ROCHESTER PRESERVATION BOARD
STAFF REPORT
For hearing scheduled for April 6, 2016

A-035-15-16

66 Park Avenue

Project Description: To legalize the replacement of front steps, railings and walkway, **and to add a walkway across the front yard.**

66 PARK AVE SCALE 1" = 1'
STAIR & RAILING DETAIL

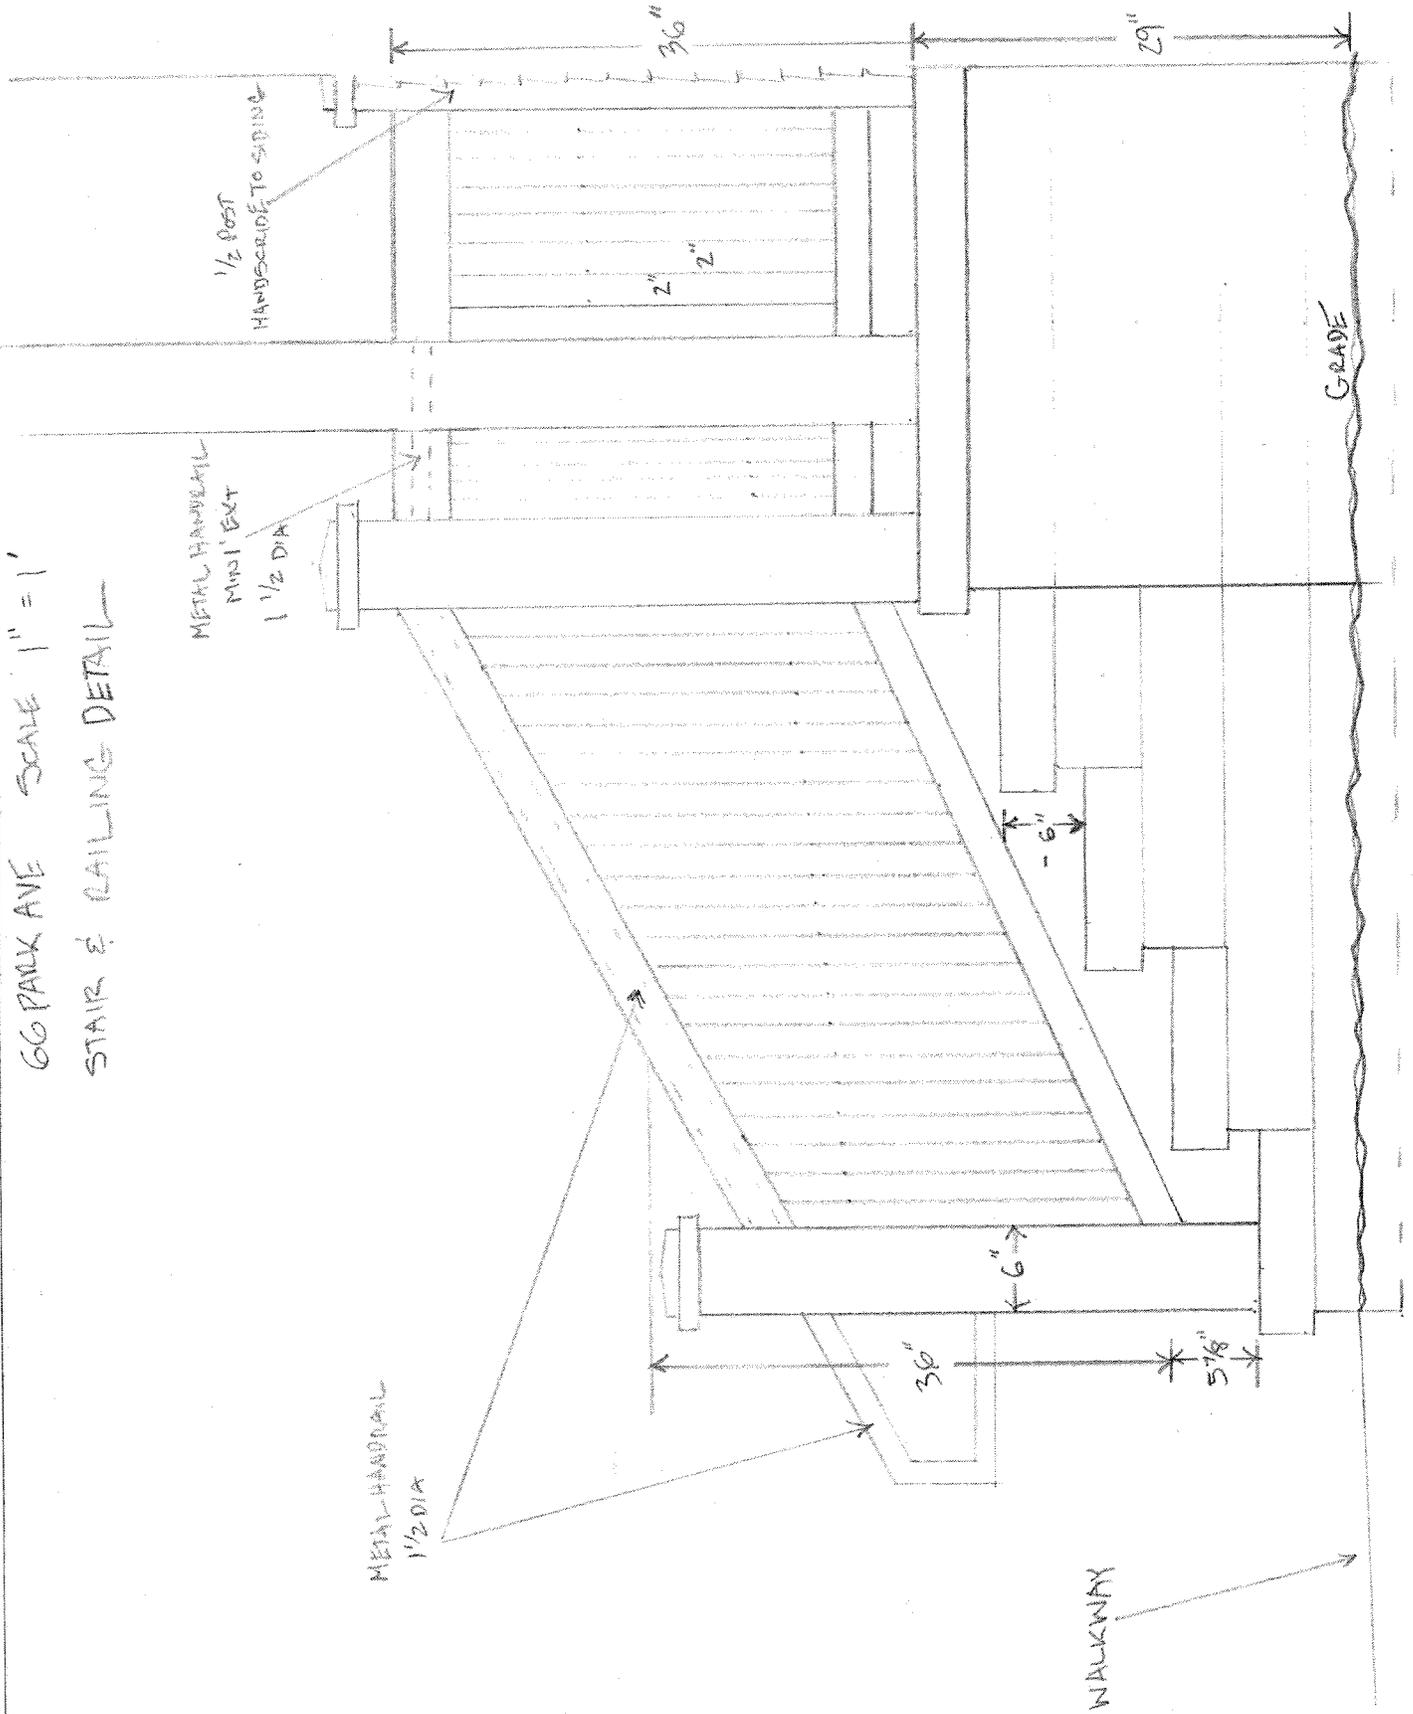
This case came before the Board in February, when members stated that although the work appears to be well done, it would not have been approved if properly proposed. Members opposed the design of the railings and the extension of the landing beyond the porch columns. They directed the applicant to return with a proposal to modify the current conditions while possibly retaining the steps and walkway.

Staff advised the applicant to consider two modifications to address the visual heaviness of the steps and landing and the landing's abnormal width. First, staff feels that the metal railing is inappropriate to the style of the house and the character of the district, and is too thin relative to the heavy masonry on which it rests. Staff suggested replacing the railing with a thicker, wooden railing that would draw the eye away from the masonry and fit better with railings throughout the district. Staff suggested considering the railings at 34 Park Avenue or those in the attached photo.

Also, because the building code requires handrails on both guardrails, staff recommended not installing the short, angled railings between the top newel posts and the porch columns. The 12" extensions of the handrails should safely fill this gap. Staff provided the attached sample photo of one way to design metal handrails.

Staff's second suggestion is to mask the edges of the landing with planter boxes, and to not install railings on the landing. The landing is less than 30" above finished grade, so guardrails are not required. If the planter boxes are substantial, designed to be permanent, and used to provide safety, they would be less likely to be removed in the future. Staff's photograph is attached.

Building code official Tim Raymond agreed that guardrails are not required if the landing is less than 30" above grade. However, handrails that comply with the code are required, and the current railings are not compliant. The handrails must extend beyond the top and bottom steps, and must return to a post, wall, etc.

PROPOSED WALKWAY

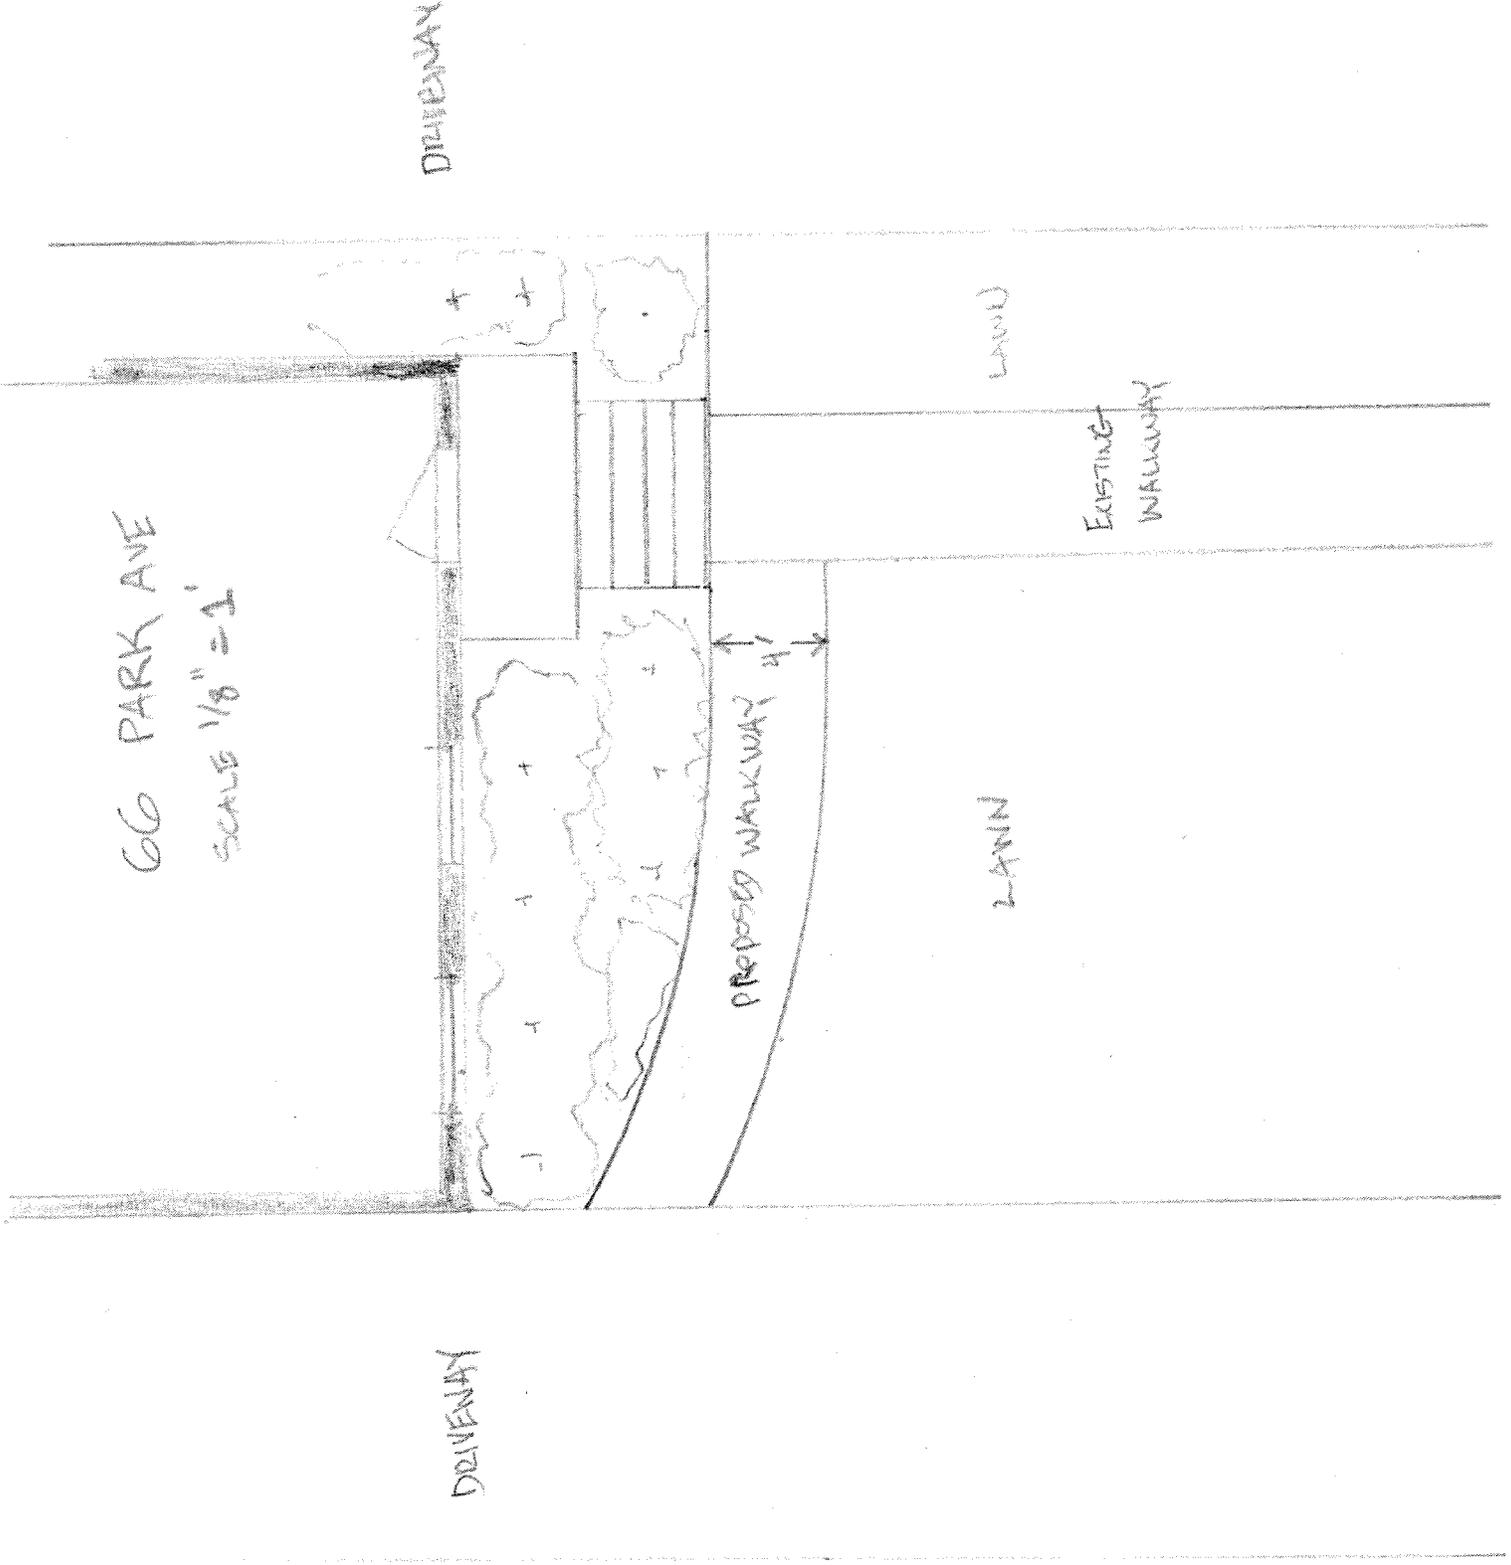
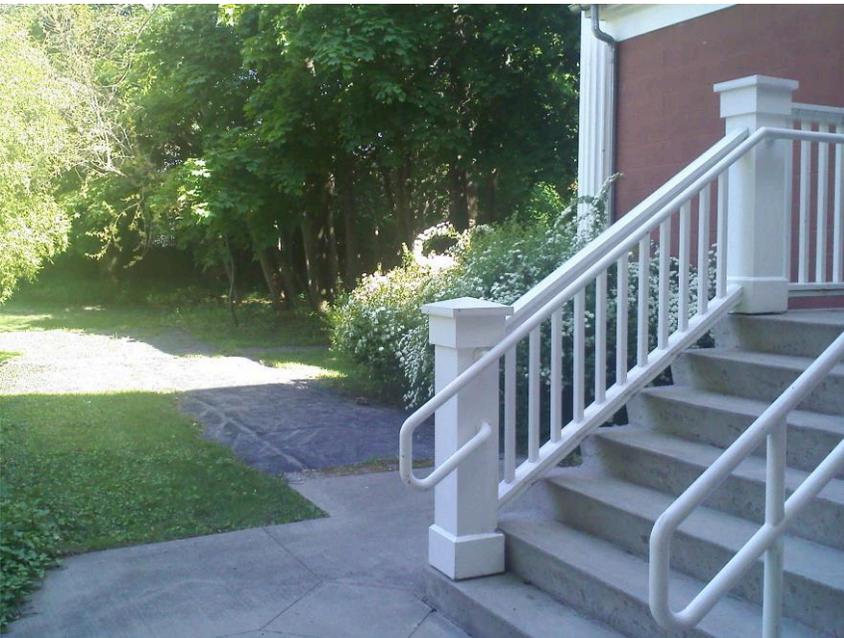
The applicant would also like to install a walkway across the front yard to connect the parking lot with the main entrance.

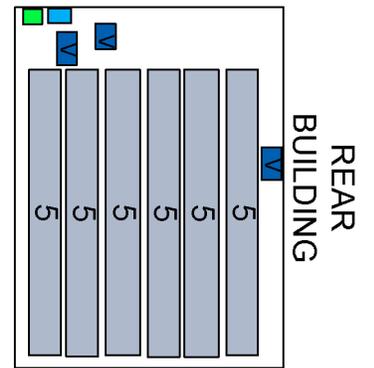
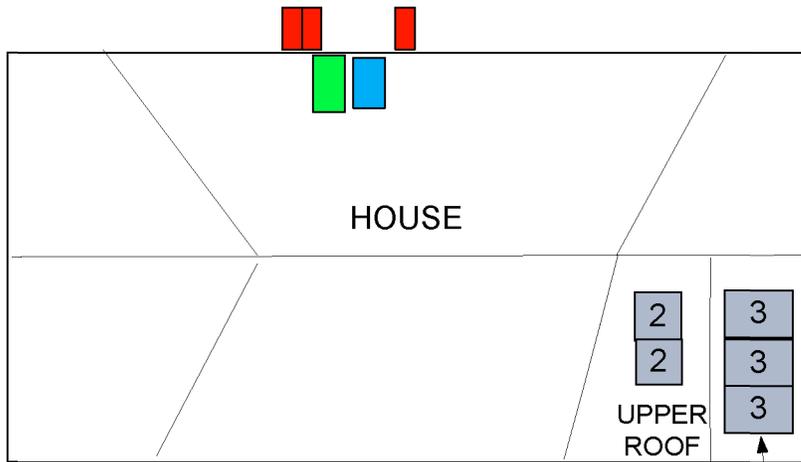
At the March hearing, the applicant presented a proposal to install 30 solar panels on the roof of the house, toward the street. The Board found that the panels would appear overly obtrusive and thus be incompatible with the historic visual character of the preservation district. Members asked the applicant to return with an alternate plan. That plan is attached.

- B. Members of the Board discussed, at length, the configuration, location and color of the panels, stating a preference to have the panels farther back on the roof to be less visible from the street. The members' general concern is that, regardless of color, the panels will be very visible on this steep, light-colored roof.

- D. In response to member's questions, Mr. Lessord stated that the panels could not be farther back on the roof because they would be shaded by adjacent roofs.
